ZONING ADMINISTRATOR MEETING AGENDA

2. SC23-0015 – Yun Li – 628 Cuesta Drive

Design Review for the modifications to an approved residential addition (SC21-0046) from a two-story house with 2,065 square feet at the first story and 1,120 square feet at the second story to a two-story house with 2,257 square feet at the first story and 1,077 square feet at the second story. This project is categorically exempt from environmental review under 15301 of the California Environmental Quality Act (CEQA). *Project Planner: Liu*

FROM: Jia Liu, Associate Planner

**TREE
 PROTECTION
 PLAN**

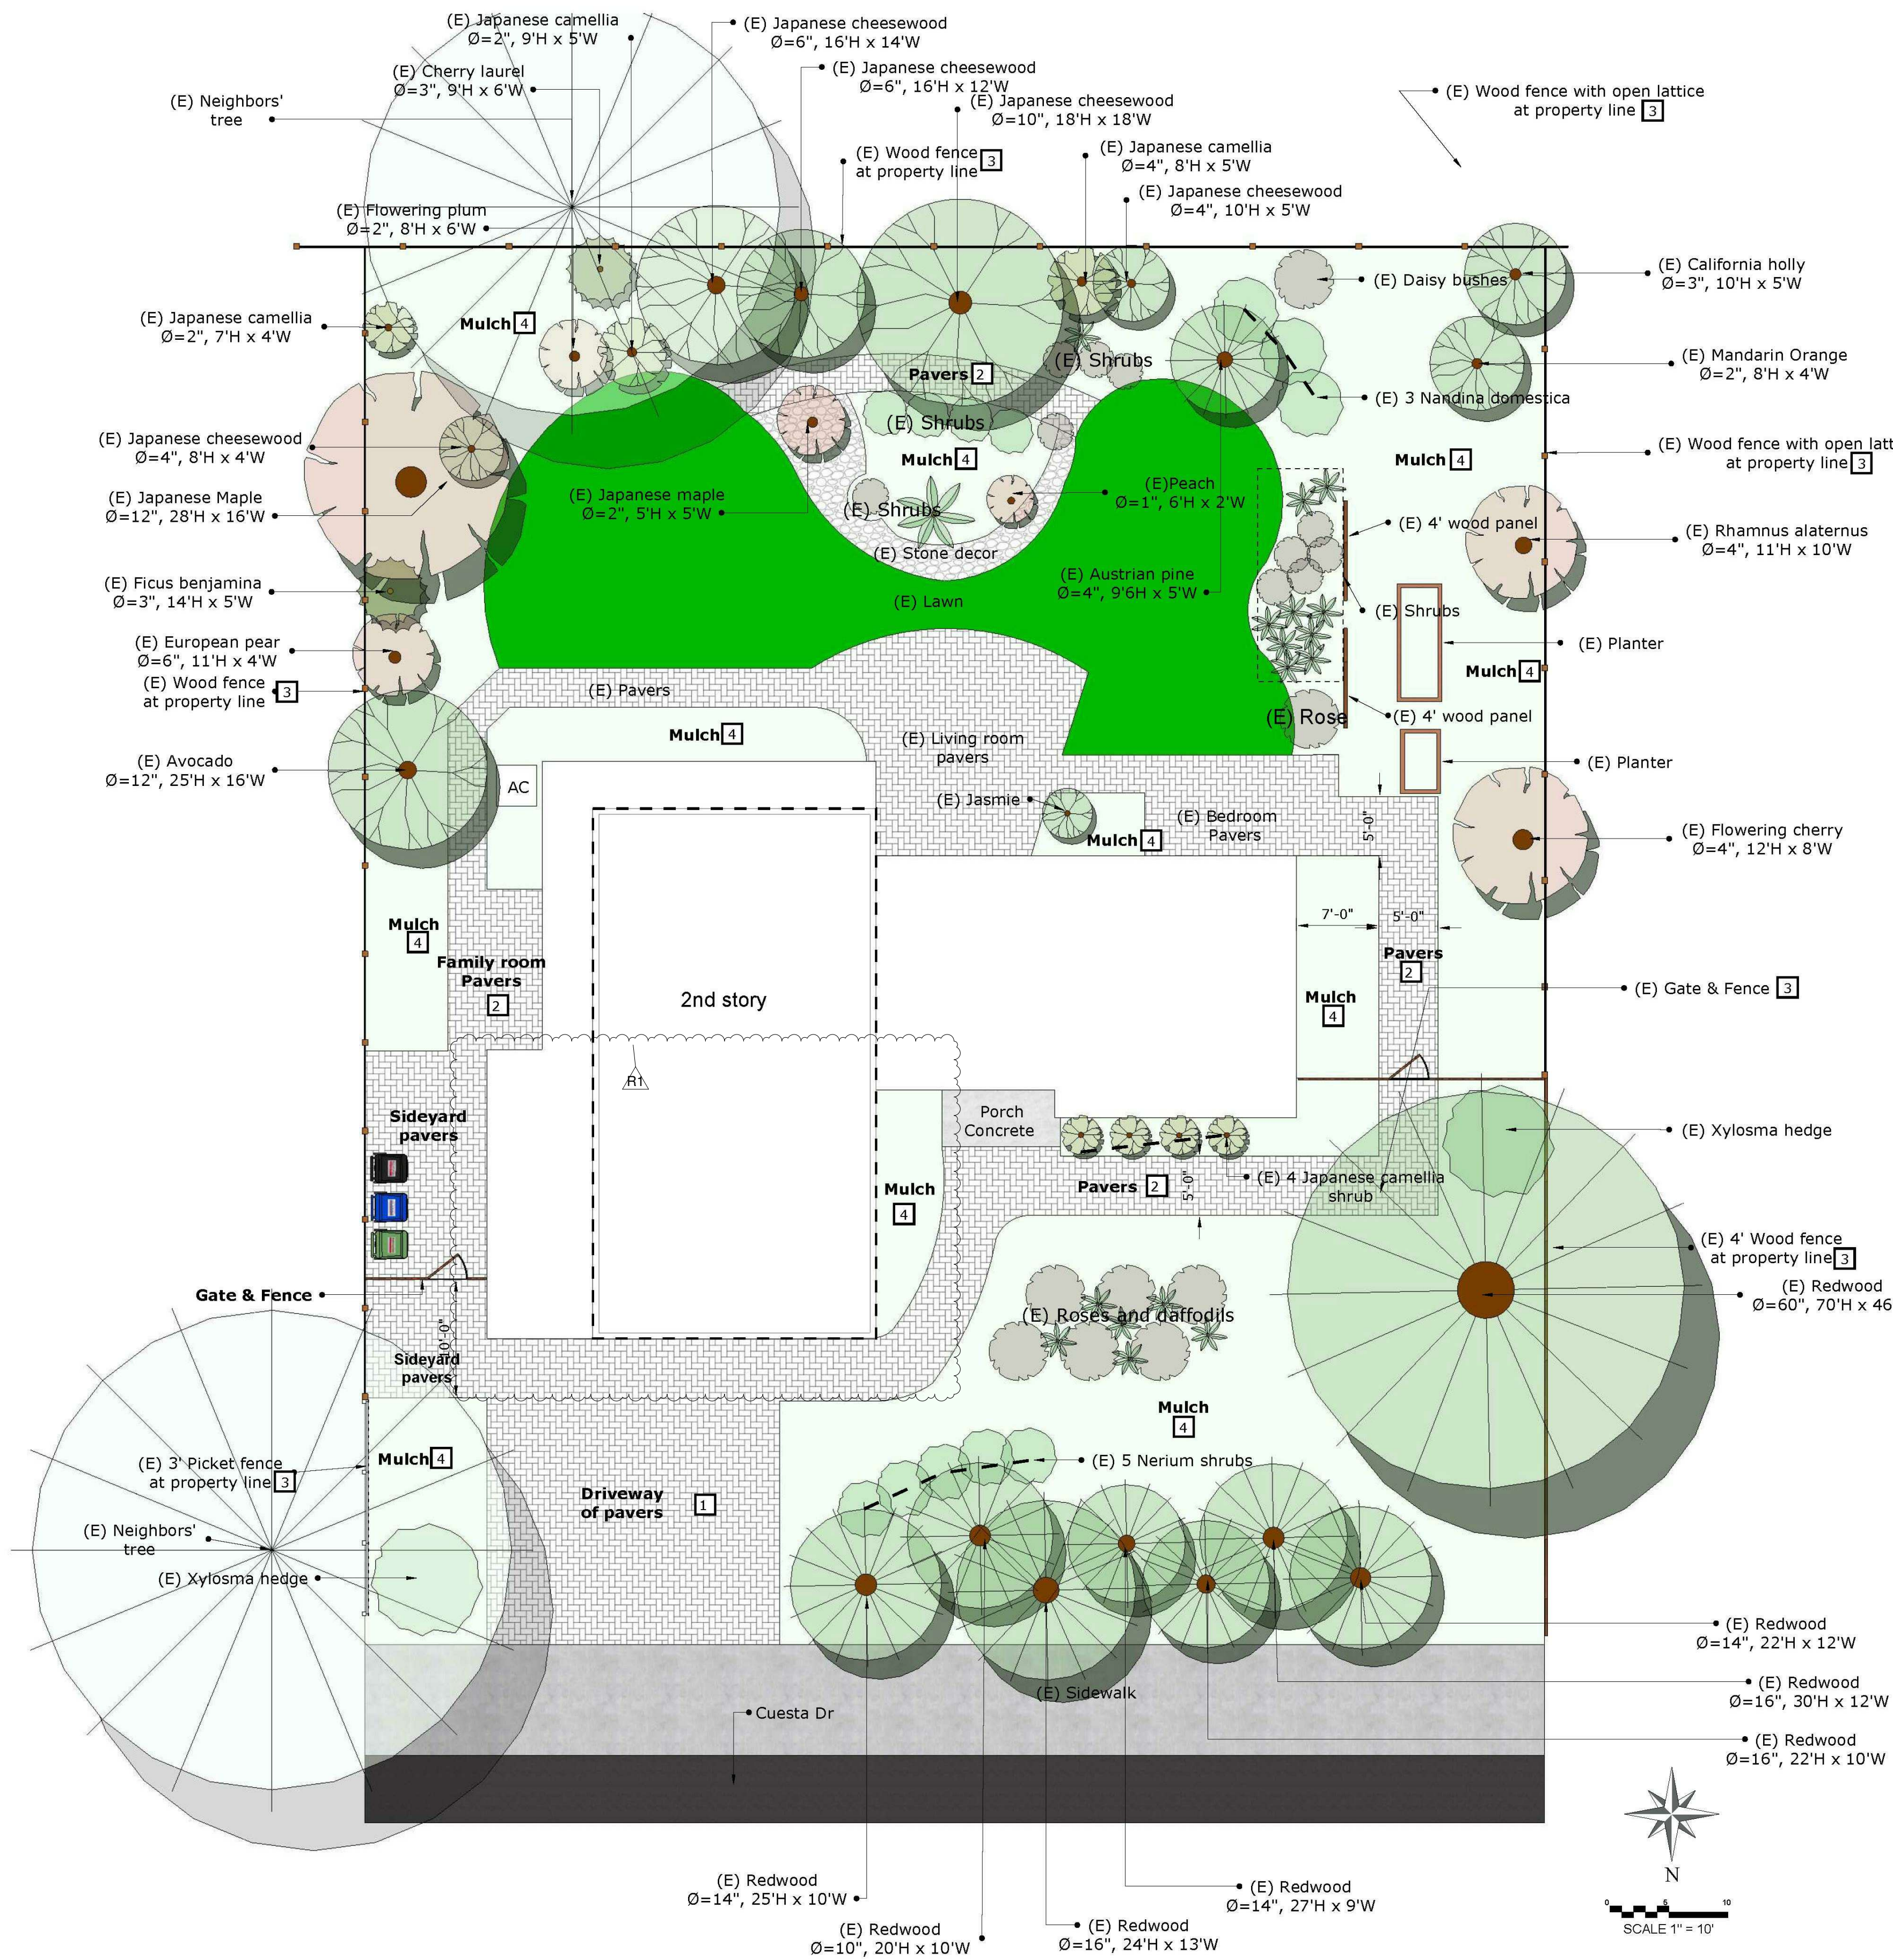
The applicant will maintain all the existing evergreen screen vegetation and trees onsite as illustrated on Sheet A-1.3 of project plans (Attachment B).
